APPLICATION NO.	FILING DATE	FIRST NAMED INVENTOR	ATTORNEY DOCKET NO.	CONFIRMATION NO.
10/524,273	08/11/2005	Javier Marti Sendra	027318-00007	1001
4372	7590	07/06/2007		
ARENT FOX PLLC 1050 CONNECTICUT AVENUE, N.W. SUITE 400 WASHINGTON, DC 20036			EXAMINER ROJAS, OMAR R	
			ART UNIT 2874	PAPER NUMBER
			MAIL DATE 07/06/2007	DELIVERY MODE PAPER

Office Action Summary	Application No. 10/524,273	Applicant(s) MARTI SENDRA ET AL.	
	Examiner Omar Rojas	Art Unit 2874

DETAILED ACTION

In re claim 1, Kosaka discloses a system of coupling between a dielectric optical guide 13 and a planar photonic crystal guide 12, characterised by the fact that it consists of a coupling structure 11 necessary for adapting the width between both guides. Figure 2 of Kosaka is reproduced below.

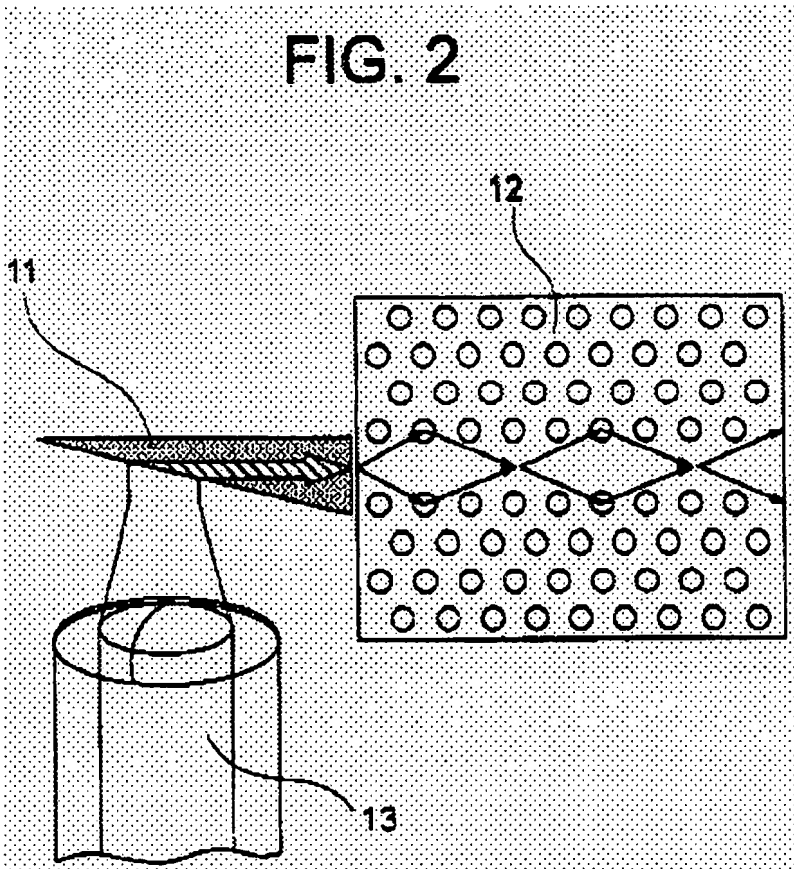
In re claim 2, the coupling structure 11 of Kosaka inherently has a length, width and shape, as seen in Figure 2, depending on the characteristics of both the dielectric guide 13 and the photonic crystal guide 12.

In re claim 3, the photonic crystal guide 12 of Kosaka inherently has a grid constant, radius and height of the cylinders and contrast of indices between the material of the columns, the material surrounding the columns and the material above and below the crystal as suggested by Figure 2.

In re claim 5, the photonic crystal guide 12 inherently has a width and a type.

Thus, Kosaka only differs from claims 1-5 in that Kosaka does not teach the introduction of point defects in the coupling structure 11 by selecting a particular number of defects and one or more defect characteristics including radius, dielectric constant, relative position and height as recited by claim 1.

Figure 17(a) of Dridi is reproduced below.

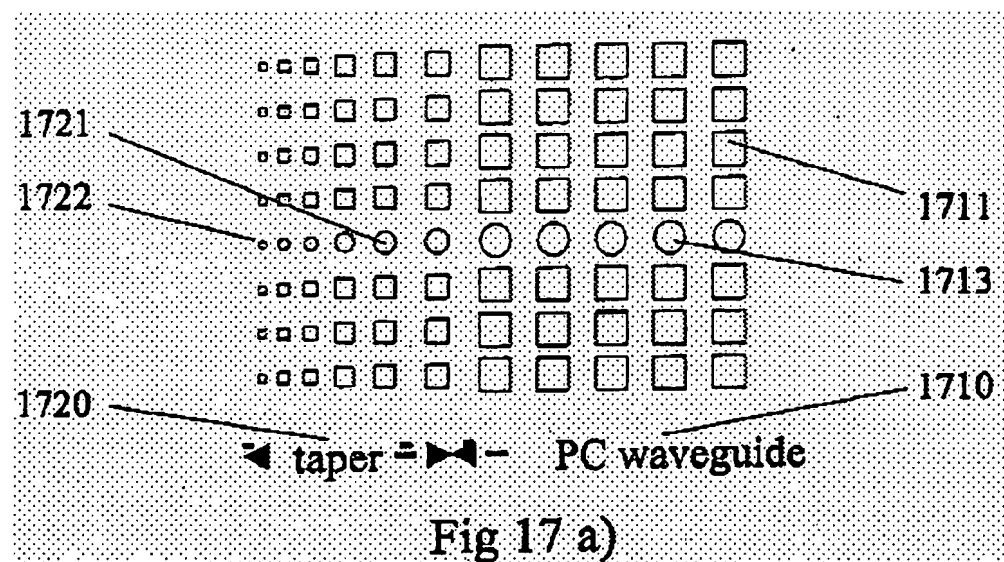
Dridi, on the hand, discloses introducing point defects 1721,1722 into a coupling structure (Figure 17) by selecting a particular number of defects and one or more defect characteristics including radius, dielectric constant, relative position and height. *See* Dridi at paragraph [0146].

The motivation for combining Dridi with Kosaka is to provide better low loss transfer of energy between the waveguides. *See* Dridi at paragraph [0047]. Therefore, it would have been obvious to one of ordinary skill in the art at the time of the claimed invention to obtain the invention specified by claims 1-5 in view of Kosaka combined with Dridi.

In re claim 6, an optimum number of defects 1721, 1722 is inherently chosen in Dridi as well as the characteristics of each one of them, both for introducing the light from a dielectric guide into a photonic crystal guide as for extracting the light from a photonic crystal guide into a dielectric guide because Dridi teaches low loss adiabatic transfer of energy between waveguides. *See* Dridi at paragraph [0047]. Therefore, it would have been obvious to one of ordinary skill in the art at the time of the claimed invention to obtain the invention specified by claim 6 in view of Kosaka combined with Dridi for the same reasons given with respect to claims 1-5.
